**Addendum No. 1
September 20, 2024**

Project: LATC Surgical Technology Renovation
Lake Area Technical College
Watertown, South Dakota

Architect: CO-OP Architecture

1 DEMOLITION FLOOR PLAN
1/8" = 1'-0"

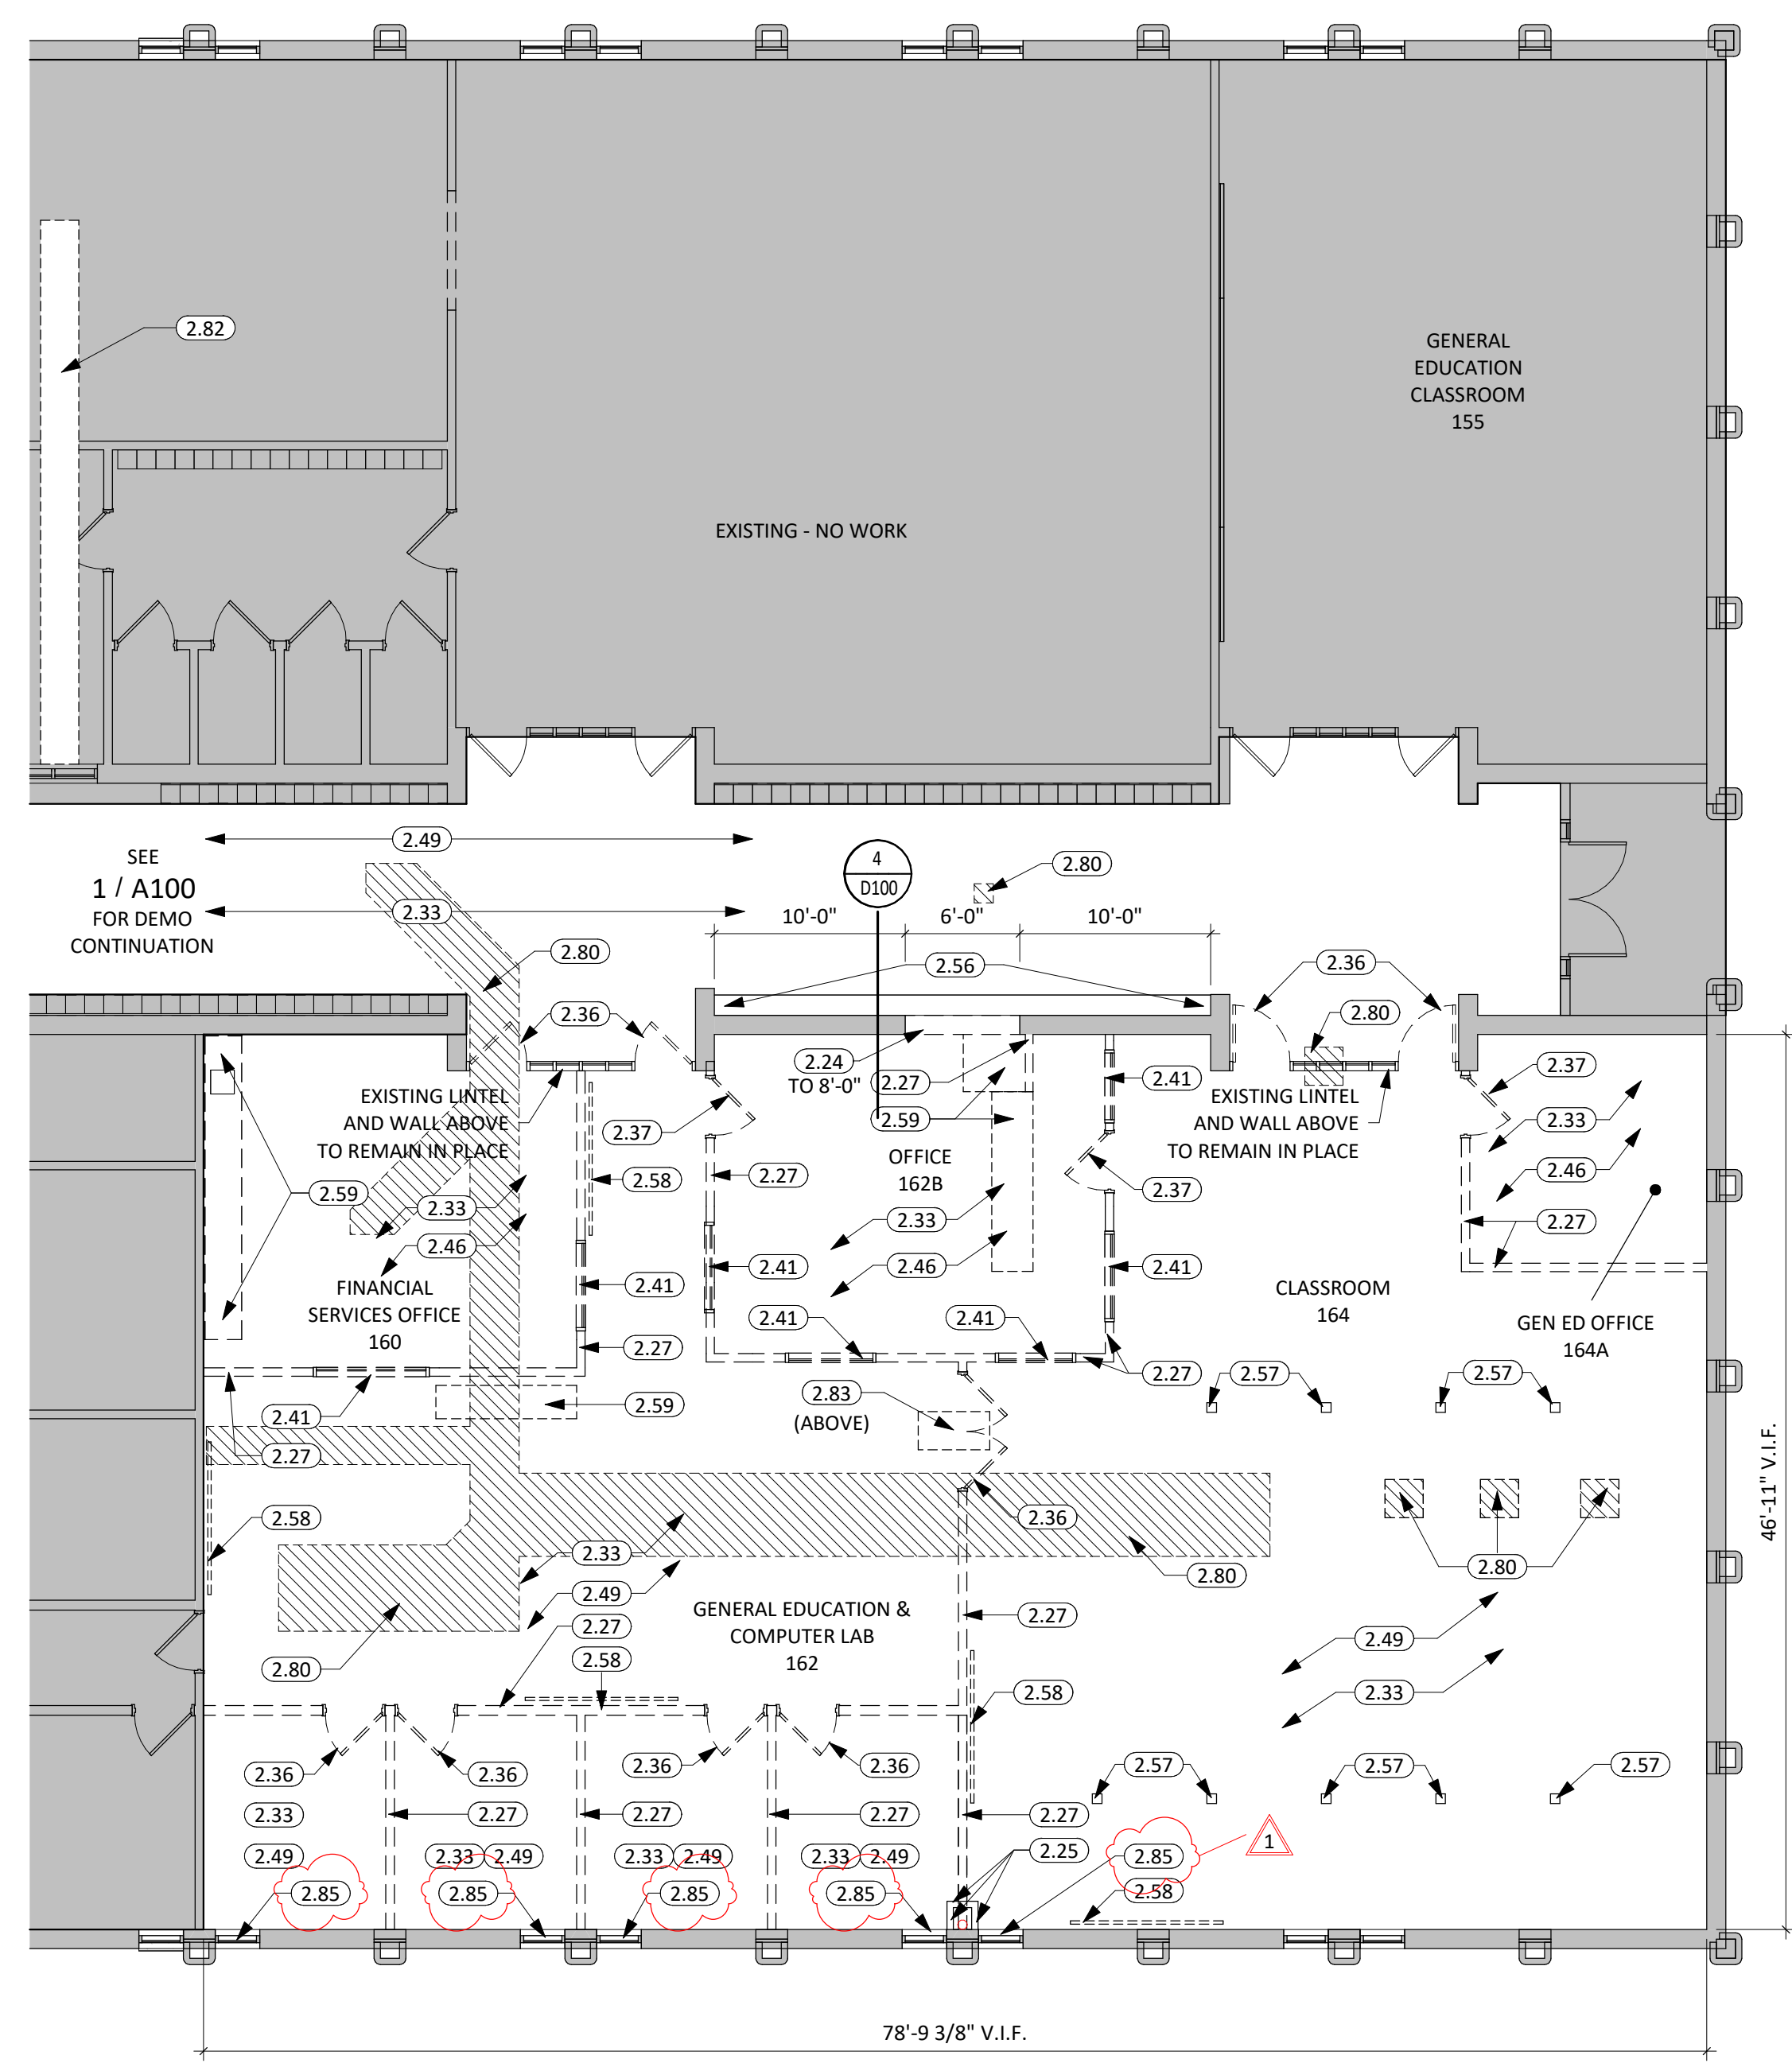
- 1) DRAWING SHEET D100
 - a. DEMOLITION FLOOR PLAN, 1/D100: Added keynote 2.85 indicating window treatment removal.
 - b. ENLARGED RR DEMO, 2/D100: Revise keynote 2.25 to 2.55 at Men's 113 and Women's 114 toilet removal.
 - c. ENLARGED RESTROOM DEMO PLAN, 3/D100: Extents of stone shelving has been added to Women's 102B. Revised keynote at entry doors to add removal of both door and transom.
 - d. CORRIDOR DEMO SECTION, 4/D100: Revise keynote 2.32 to 2.33.
- 2) DRAWING SHEET A121
 - a. Add WP-1 to wall finish of room 160B in room finish schedule. See finish plan for extents.

M401

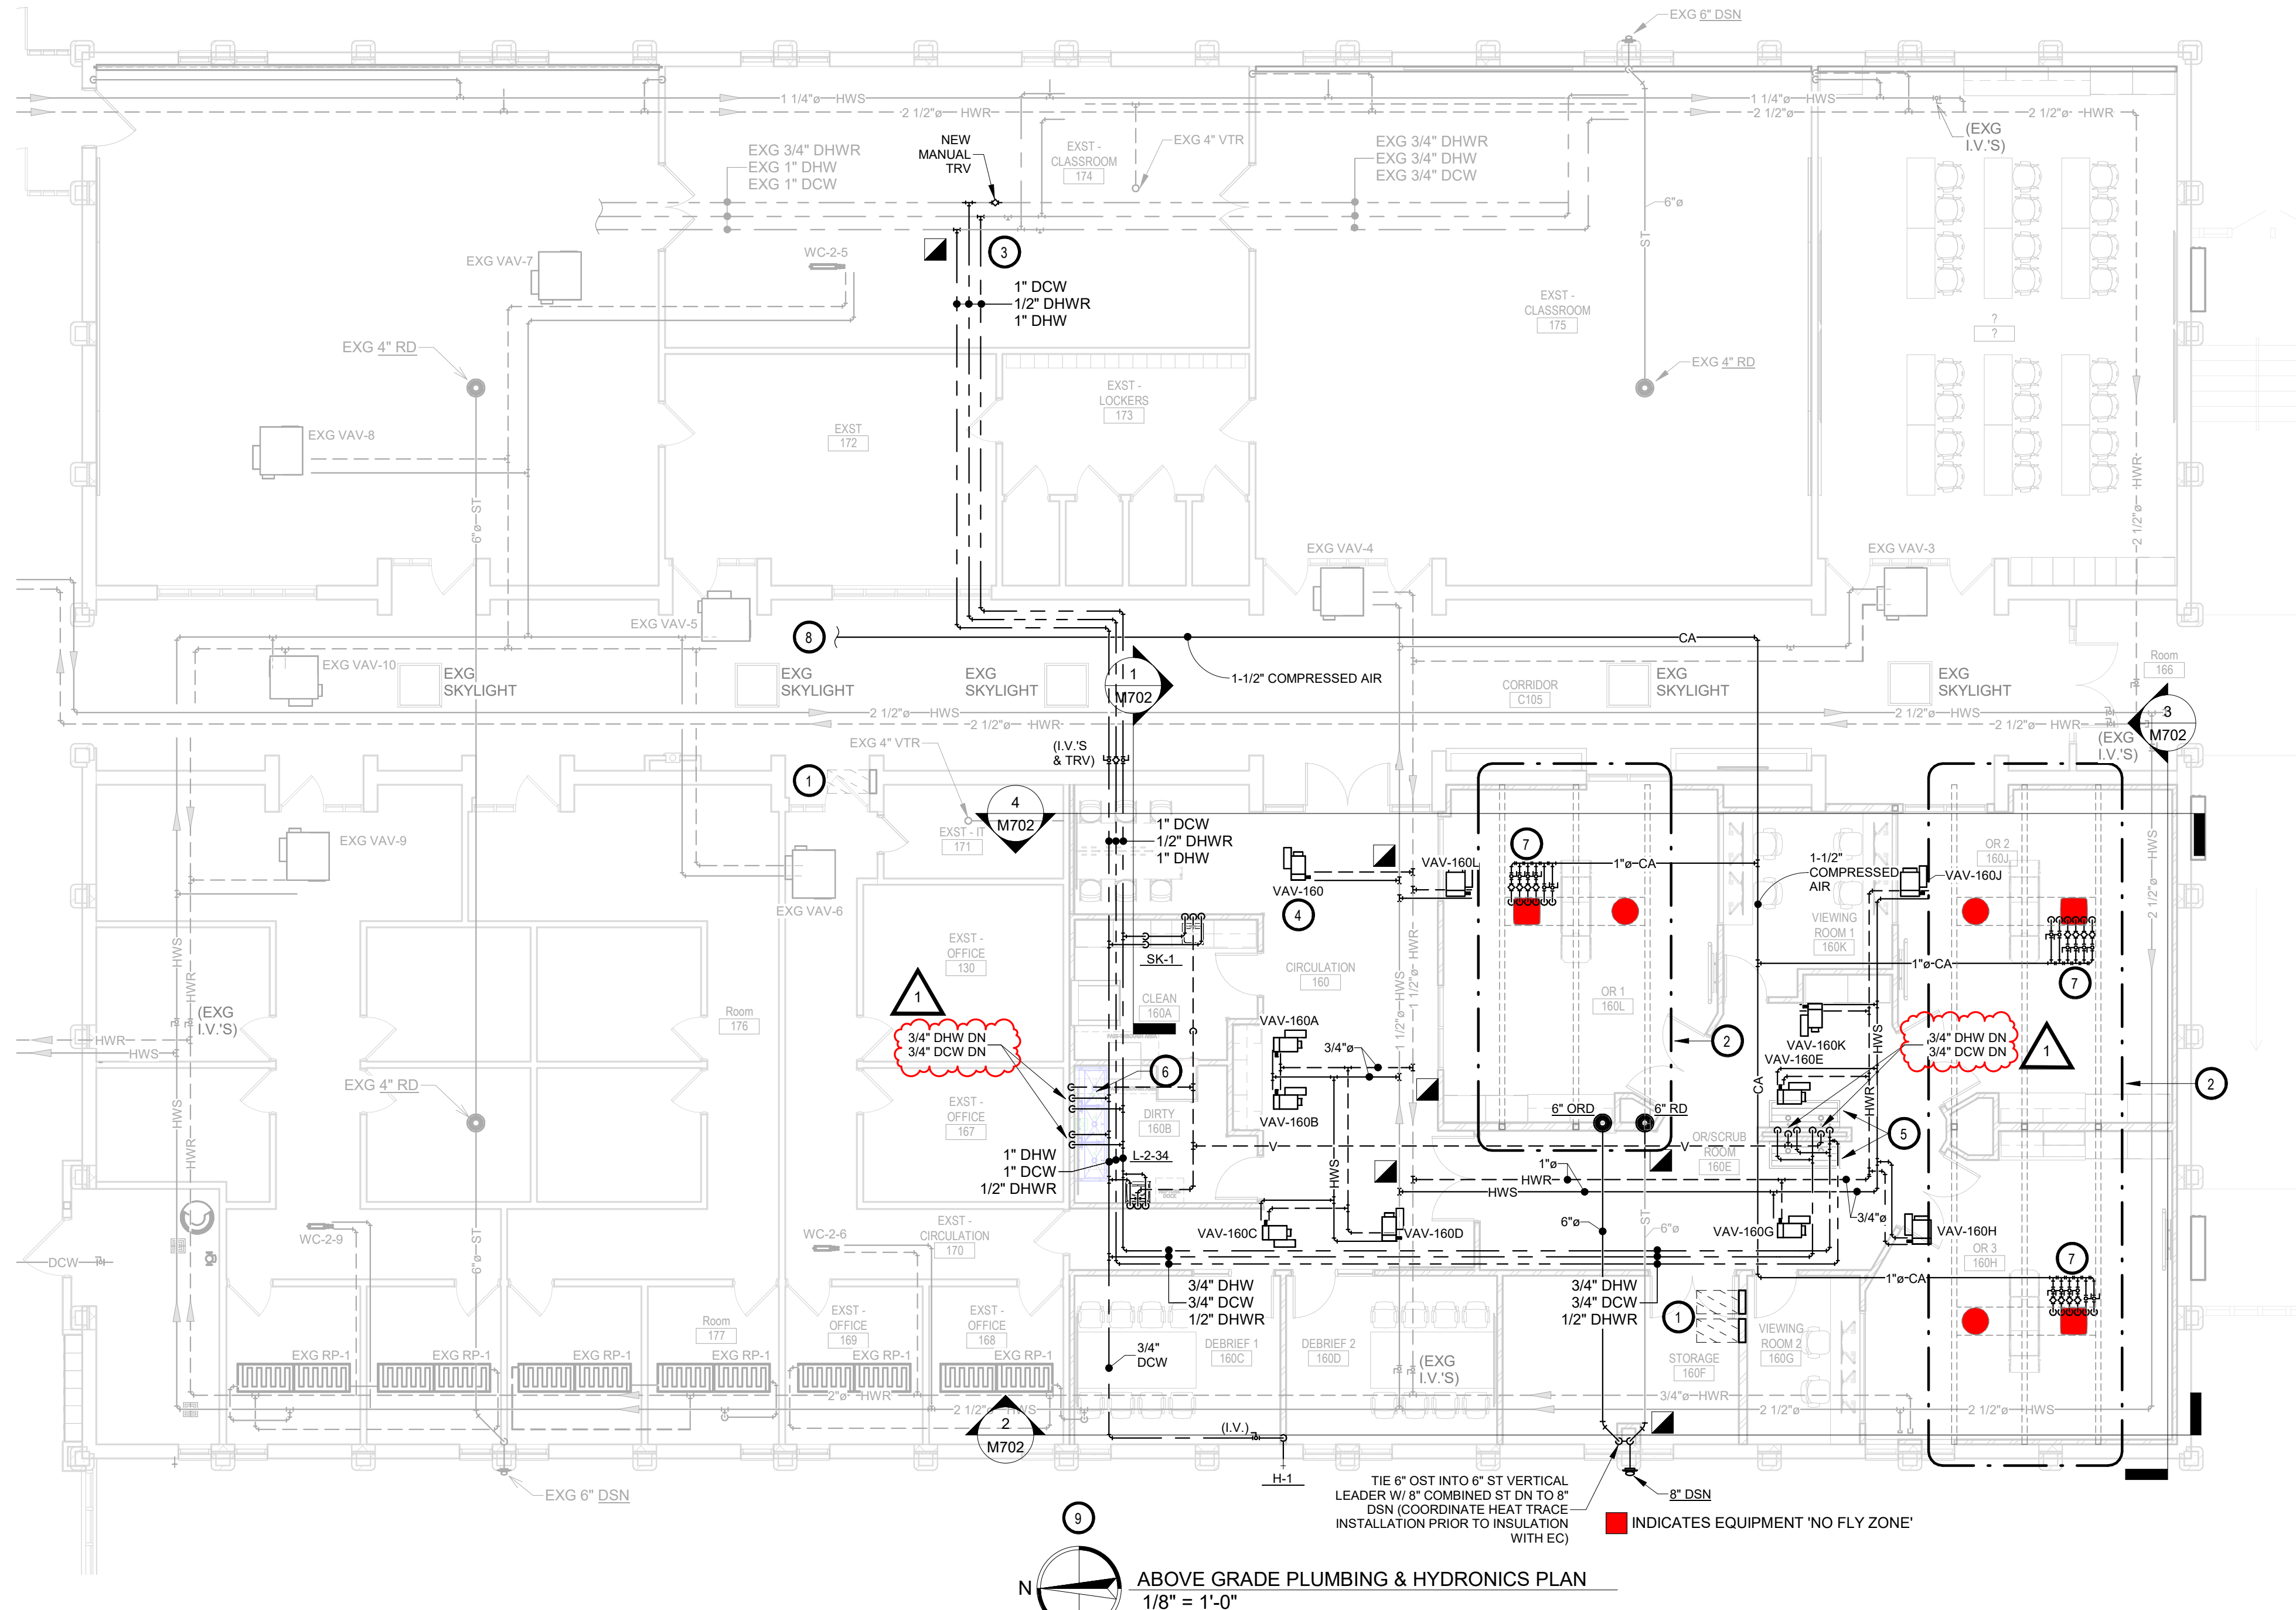
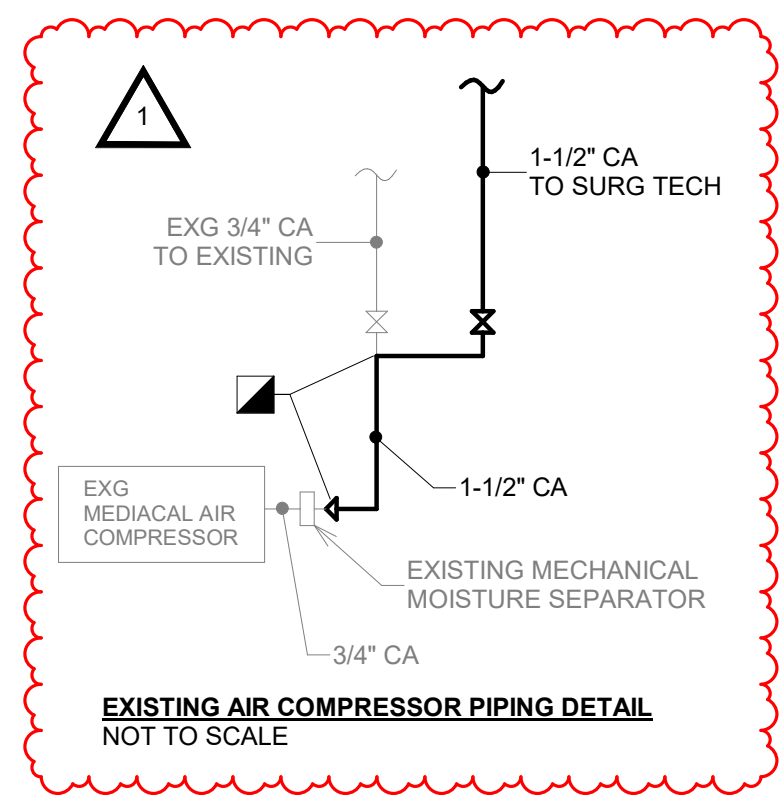
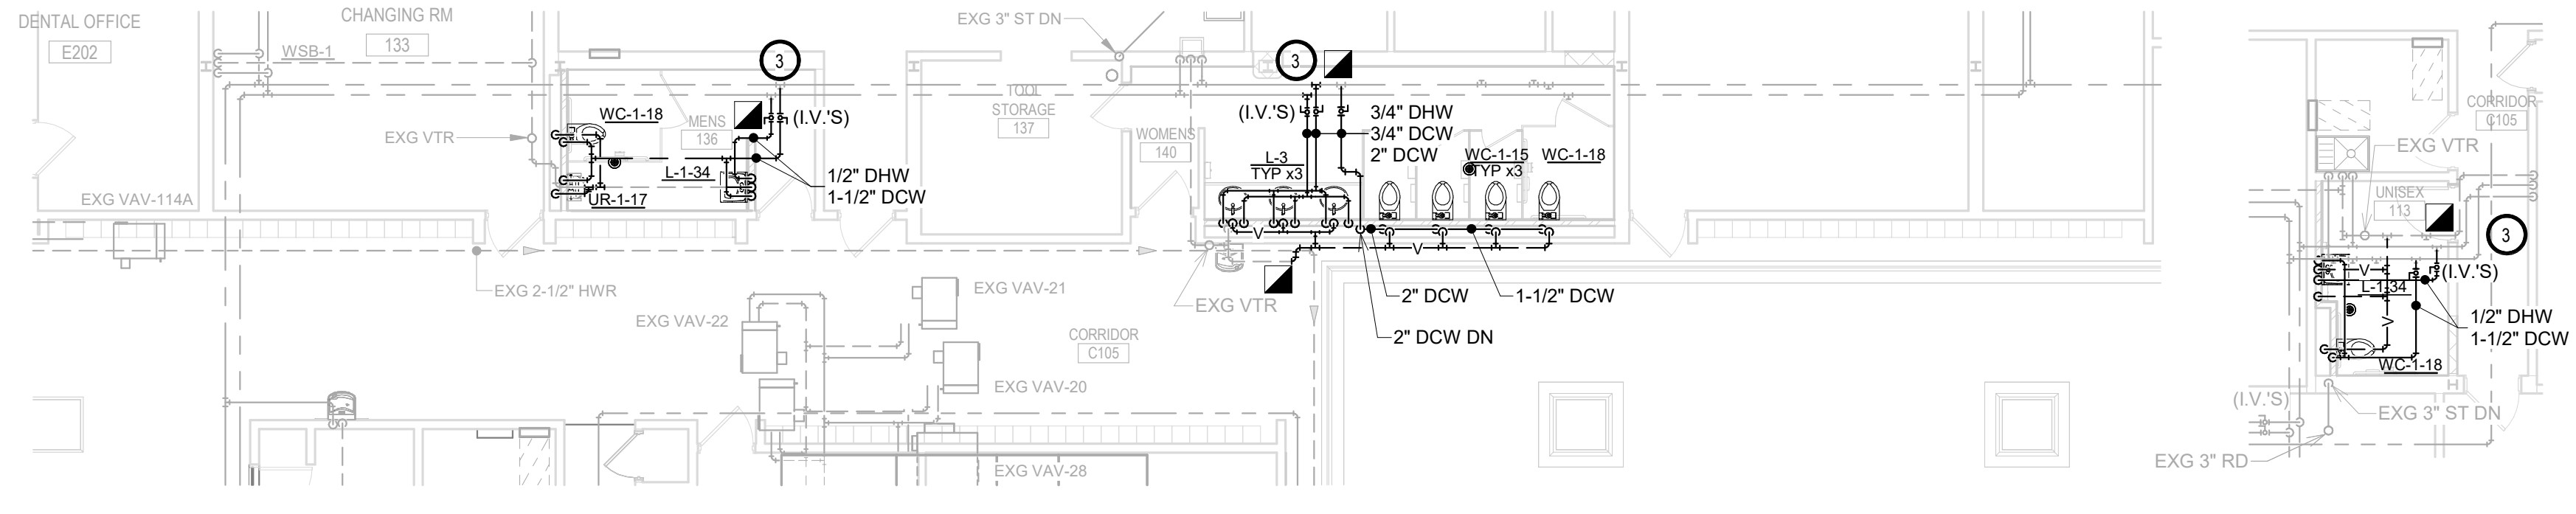
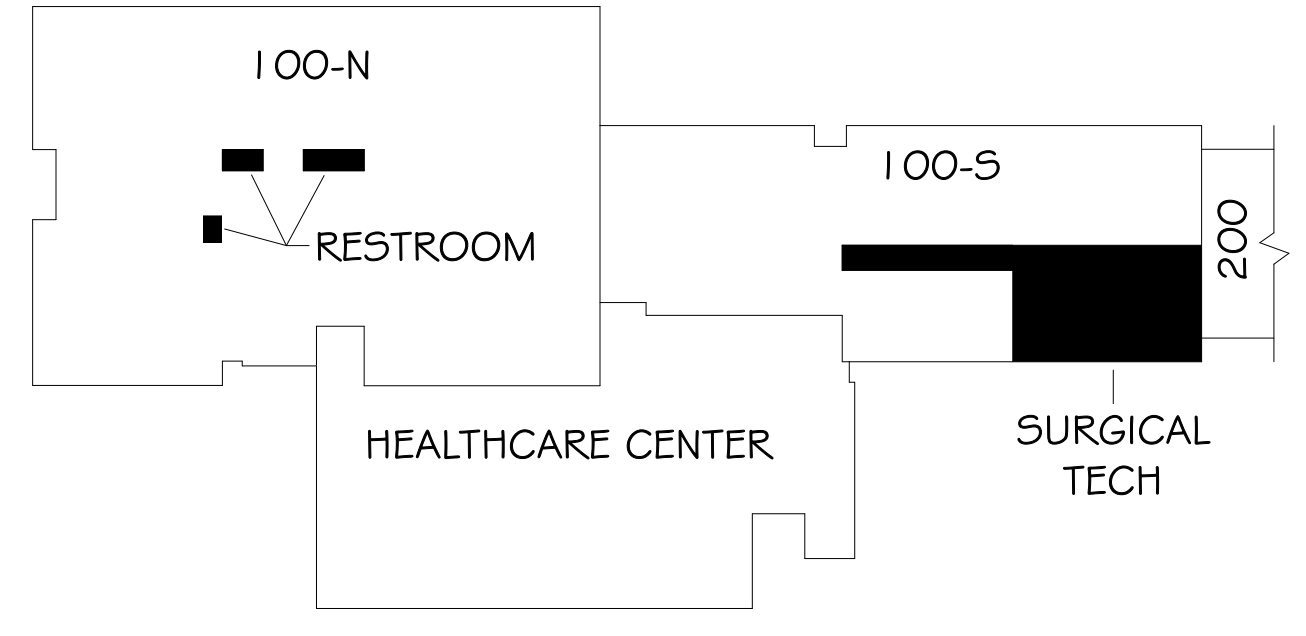
4. Sheet M401 – Above Grade Plumbing & Hydronics Plan – see the attached revised sheet for revisions to the compressed air piping, and installation of Owner provided sinks.
